**PLANNED UNIT DEVELOPMENT &
SUBDIVISION STAFF REPORT****Date: April 17, 2003**

DEVELOPMENT NAME Middle Bay Marine Subdivision

APPLICATION NUMBER 10 DATE April 17, 2003
APPLICANT Middle Bay Marine Subdivision
REQUEST Planned Unit Development

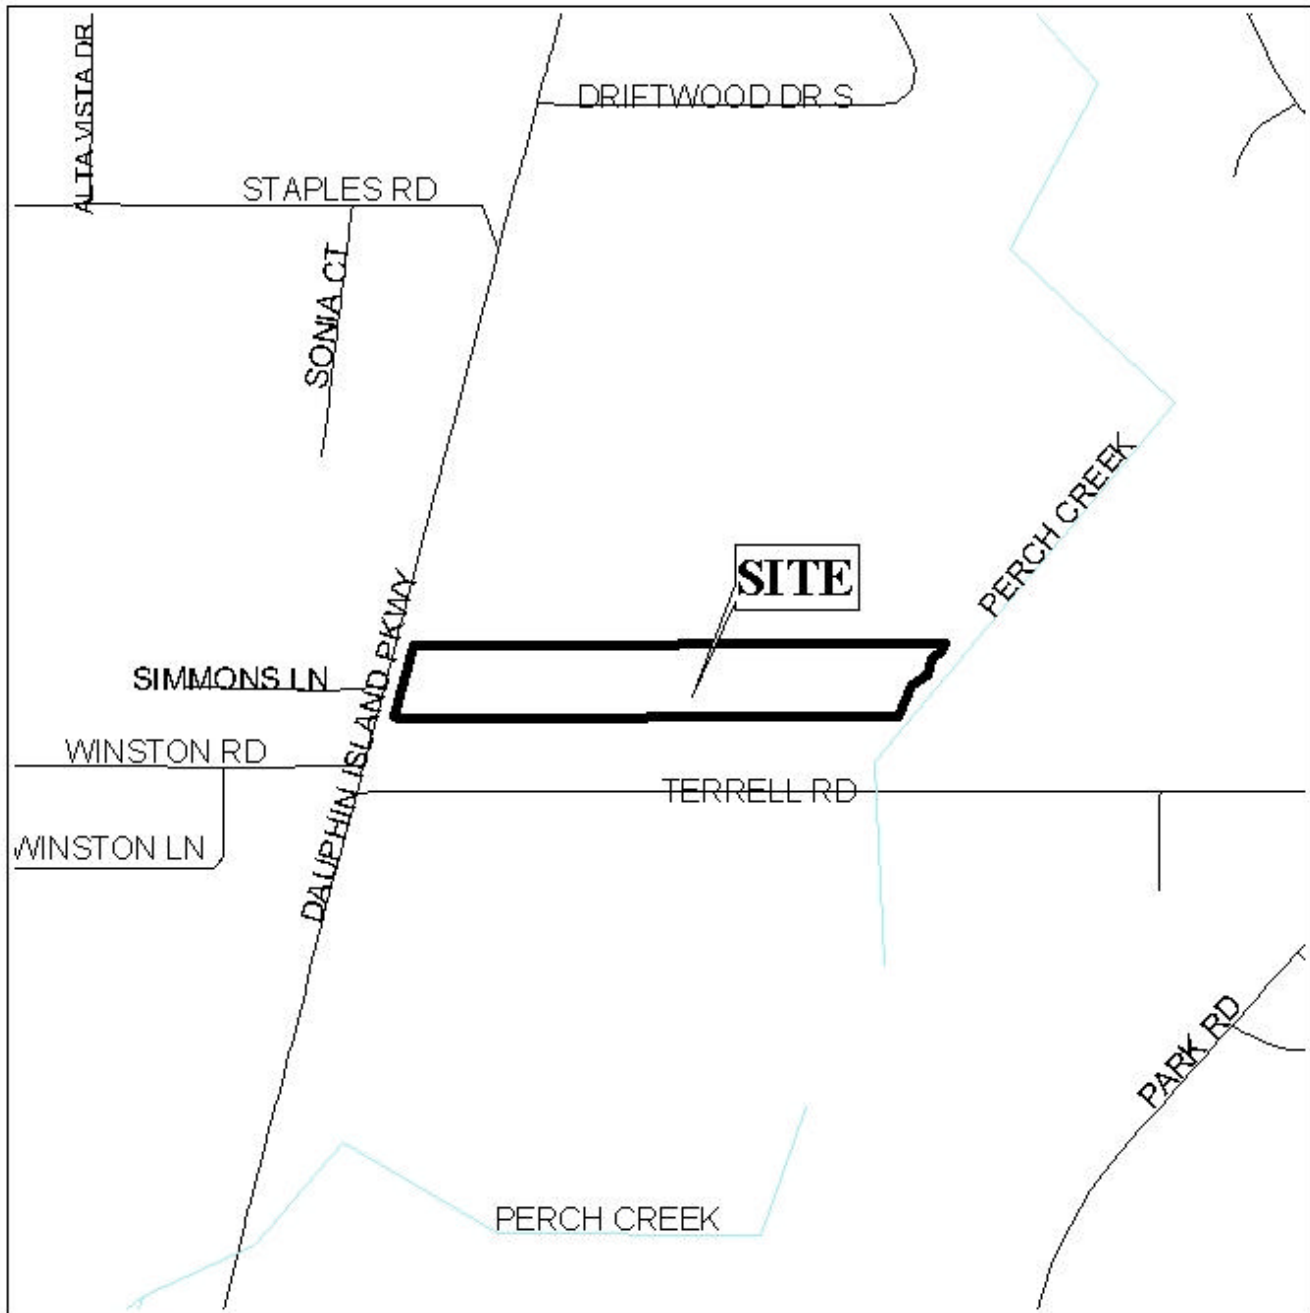
The plan meets the general requirements for PUD approval. However, there are several minor issues relating to access, the number of parking spaces provided, and use of gravel for some of the required parking.

The plan indicates two drives to Dauphin Island Parkway. As stated above, Dauphin Island Parkway is a major street, and with less than 300' of frontage, limiting the site to one curb cut would be appropriate.

The parking calculations provided by the applicant indicate that parking is provided for 3,200 sq.ft. of office area and for two warehouse employees. However, no parking is provided for the showroom area; parking requirements are for gross square footage. While the requirements may be separated between office/retail and warehouse, the display area would be considered part of the retail area and included for parking calculations. Therefore, additional parking spaces would be required.

Of the parking spaces shown on the plan, six are located behind the main building and are proposed to be gravel. While the gravel storage area would be allowed, parking and maneuvering areas are required to be paved.

Planned Unit Development: based on the preceding, it is recommended that this application be approved subject to the following conditions: 1) limited to the site plan submitted, as required to be revised by this approval; 2) limited to one curb cut to Dauphin Island Parkway, exact location and design to be approved by Traffic Engineering and ALDOT; 2) existing curb cuts to be closed and removed; 3) parking to be provided at 1:300 sq.ft. for office and retail/display area(s), configuration to be approved by Urban Development; 4) all parking and maneuvering for parking to be paved, gravel surface only allowed for storage yard; 5) provision of buffering where the site abuts residentially zoned properties; 6) developer to obtain all necessary federal, state and local approvals prior to the issuance of any permits; and 7) full compliance with all municipal codes and ordinances.

Subdivision: the plat meets the minimum requirements of the Subdivision Regulations and is recommended for Tentative Approval subject to the following conditions: 1) placement of a note on the final plat stating that the site is limited to one curb cut to Dauphin Island Parkway, exact location and design to be approved by Traffic Engineering and ALDOT; and 2) developer to obtain all necessary federal, state and local approvals prior to the issuance of any permits
